## DECISION OF THE PLANNING COMMISSION

**CLASS 3 DESIGN REVIEW / CLASS 3 SITE PLAN REVIEW / CLASS 2  
DRIVEWAY APPROACH PERMIT / TREE REGULATION VARIANCE CASE NO.  
DR-SPR-DAP-TRV18-07**

**SUMMARY:** Proposed development of a new 111-unit apartment complex.

**LOCATION:** 1881 Wiltsey Road SE, Salem, OR 97306

**SDR3**

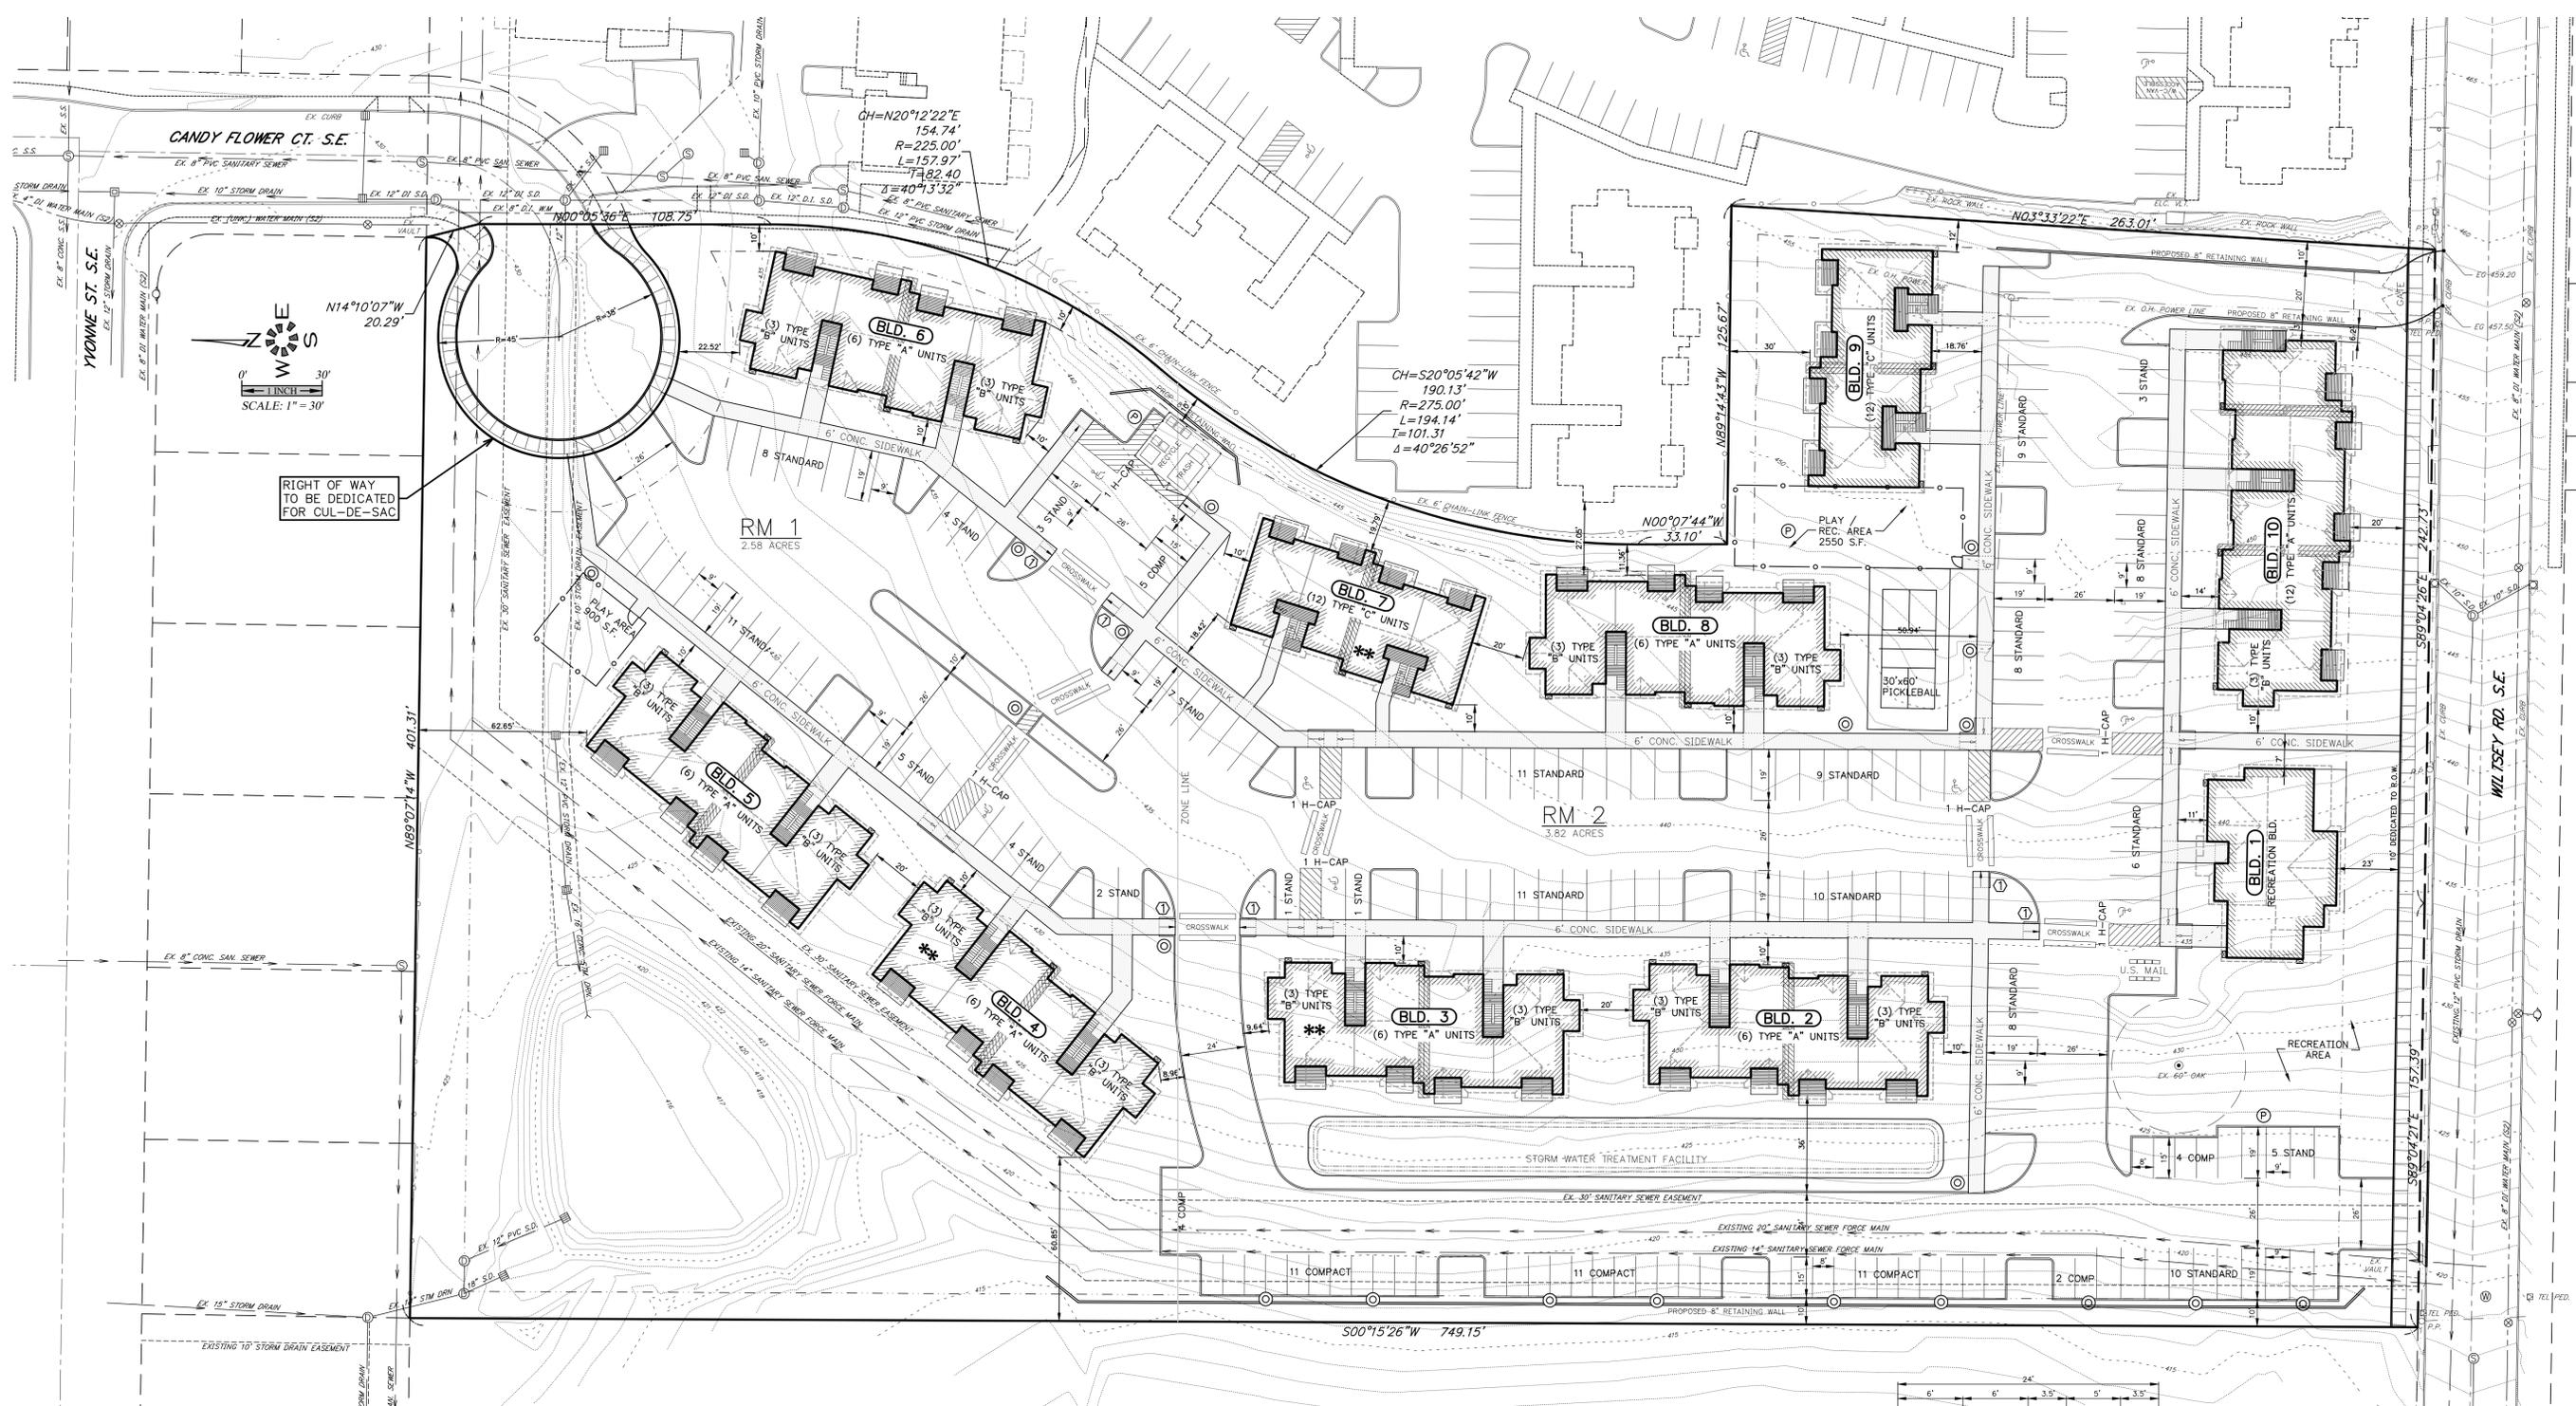
Proposed building 10 is on the setback line adjacent to Wiltsey Road SE and is approximately 135 feet in width. In addition, proposed building 1 is approximately 70 feet in length, but is located off the 20 foot setback. The applicant is requesting a reduction to the buildable width standard to provide an open space area that preserves an existing significant tree near the southwest portion of the property.

**Finding:** The proposed site plan indicates that the enclosure walls will be cmu block. A bumper curb 12 inches inside the perimeter of the outside walls of the enclosure is required, however the curb is not indicated on the proposed plans.

**Finding:** The applicant's statement and proposed site plan does not address the minimum off-street loading requirement for the development.

**Condition 3:** Prior to building permit issuance, the site plan shall be modified to include a minimum of two off-street loading spaces for the proposed use, meeting applicable location and dimension requirements of SRC Chapter 806.

**L1.1**

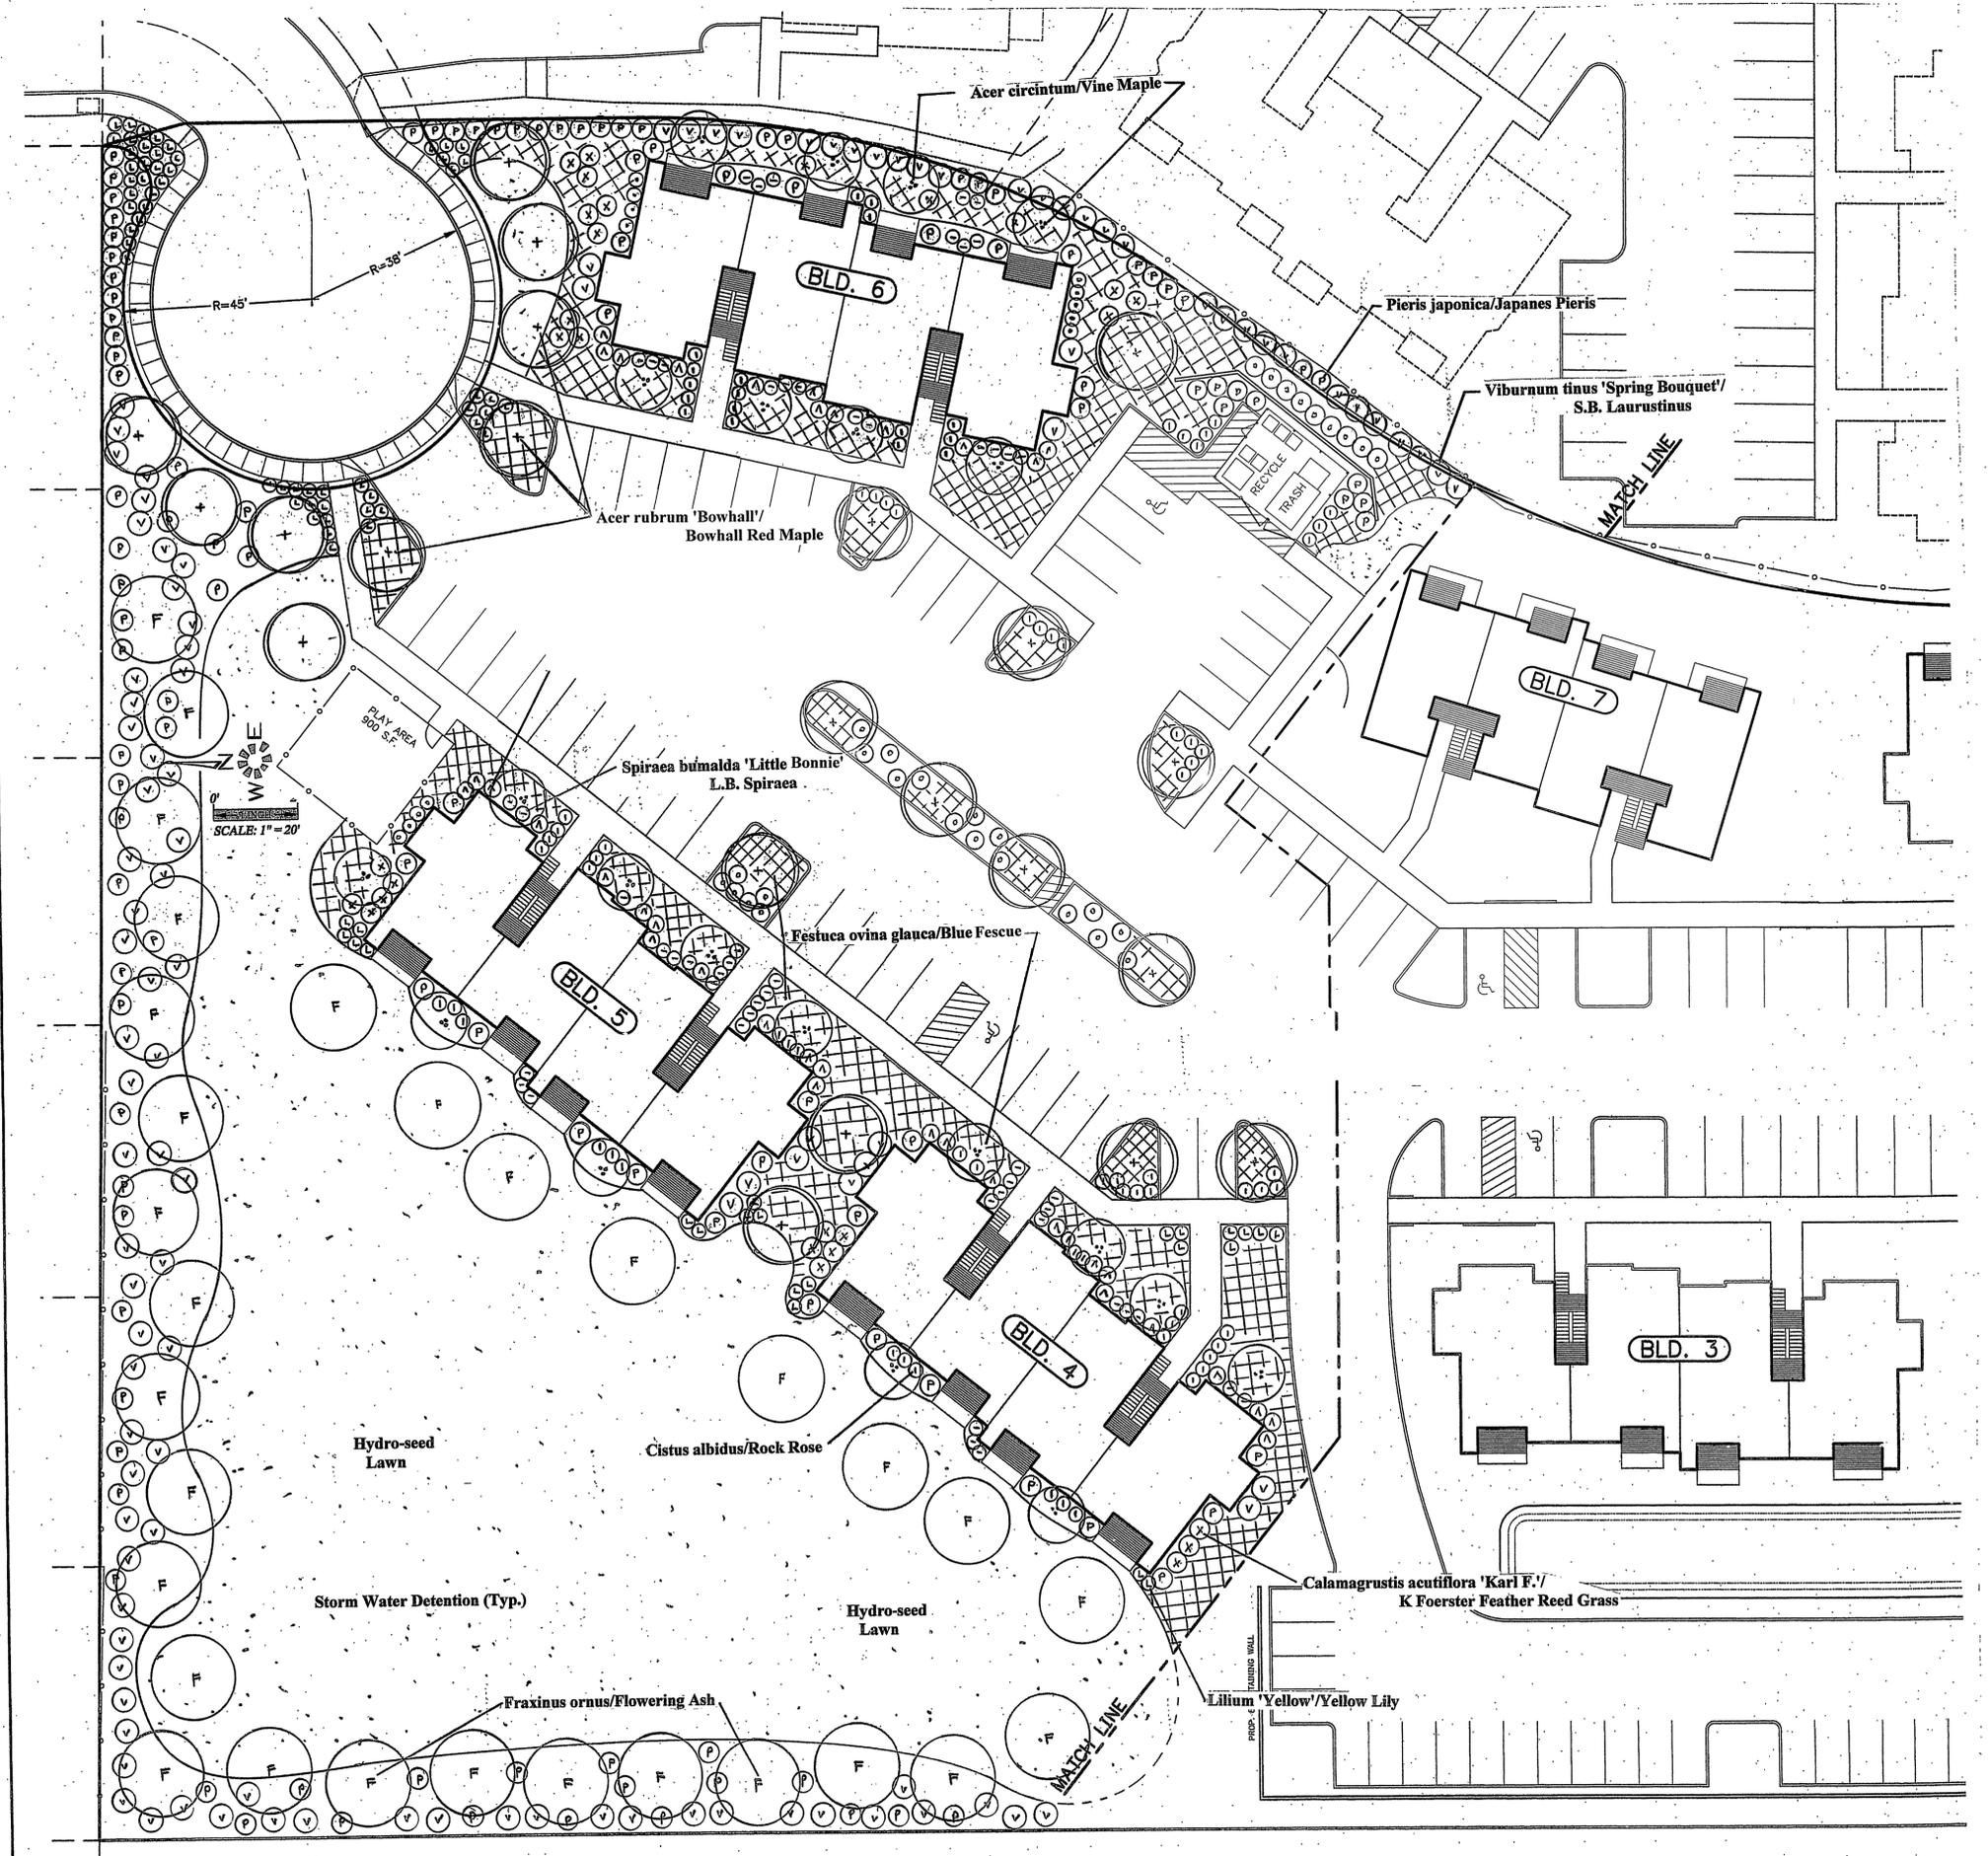
**Finding:** The applicant's existing conditions plan indicates that there are 321 trees on the subject property. One existing significant tree will be preserved with the proposed development, the remaining 320 trees are proposed for removal. Per SRC 807.030(d)(2), 241 trees may be removed ( $321 \times 0.75 = 240.8$ ), but for each tree removed beyond 241, a minimum of two new trees shall be planted in addition to the landscaping required under SRC Chapter 807. Two trees shall be replanted to replace each of the 79 trees removed in excess of 75 percent for a total of 158 replacement trees.

**Condition 4:** Per SRC 807.030(d)(2), when more than 75 percent of the existing trees are proposed for removal, a minimum of two replacement trees shall be incorporated into the landscape plan and planted, in addition to the landscaping required under this chapter. For the removal of 79 trees in excess of 75 percent, a total of 158 replacement trees shall be provided.
